Supplemental Biological Resources Report

**SUPPLEMENTAL BIOLOGICAL RESOURCES REPORT
FOR THE
LOS ANGELES AERIAL RAPID TRANSIT PROJECT
LOS ANGELES, CALIFORNIA**

The Los Angeles Aerial Rapid Transit Final Environmental Impact Report

September 2023

Figure 4-1. Areas of Woodland Habitat Proposed for Removal within BSA, in Relation to Similar Habitat in Surrounding Area

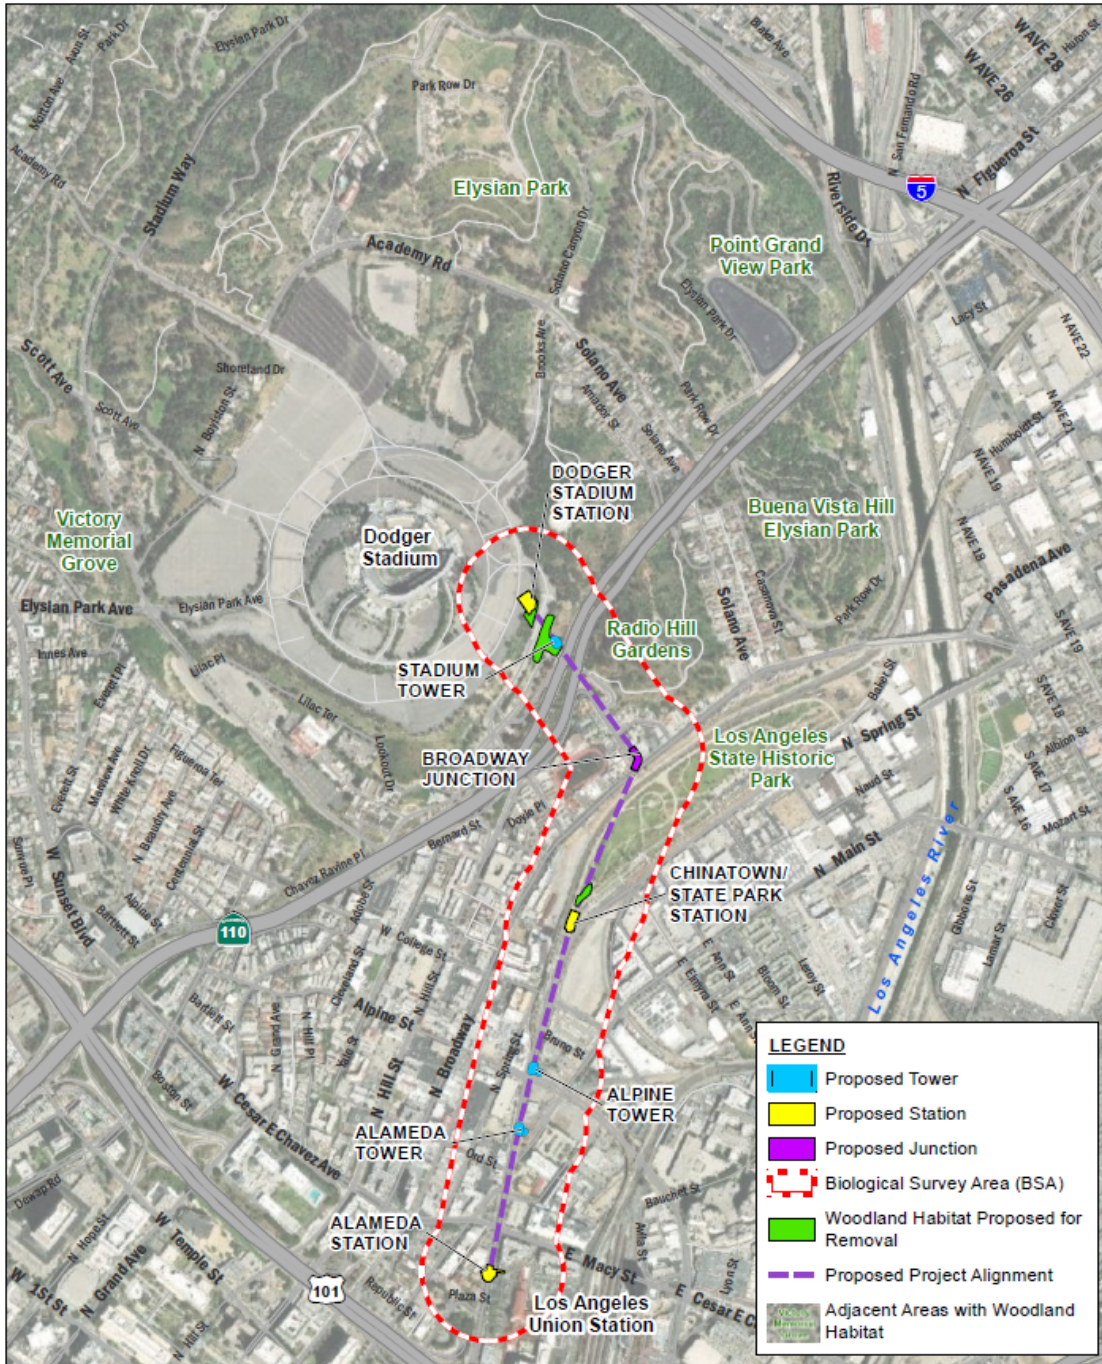
The only areas of tree removal that could be potentially described as wooded habitat are the following: the small grove of Fremont cottonwood trees at the western end of the Los Angeles State Historic Park, the non-native woodland at the Stadium Tower and associated fire buffer, and the non-native woodland at the Dodger Stadium Station location. The total area of wooded

habitat that would be removed in each of these areas is 0.24, 1.02, and 0.39 acres, respectively. These areas are relatively small amounts of wooded habitat, compared to the amounts available in the immediately surrounding areas, such as Elysian Park (approximately 600 acres alone, much of which is wooded), Radio Hill Gardens, Victory Memorial Grove, and Point Grand View Park (Figure 4-1).

In the short-term, the removal of trees will result in a marginal reduction of suitable tree habitat for nesting birds, roosting bats, and other wildlife in the vicinity of the proposed Project. Common wildlife species would be expected to utilize adjacent habitats, and substantial population level impacts to common species would not be expected due to the small amount of habitat loss relative to the amount of habitat available in surrounding areas. In the long-term, the replacement of the 145 large trees proposed for removal with 242 new trees (Table 4-2) would more than offset any realized impacts associated with the Project.
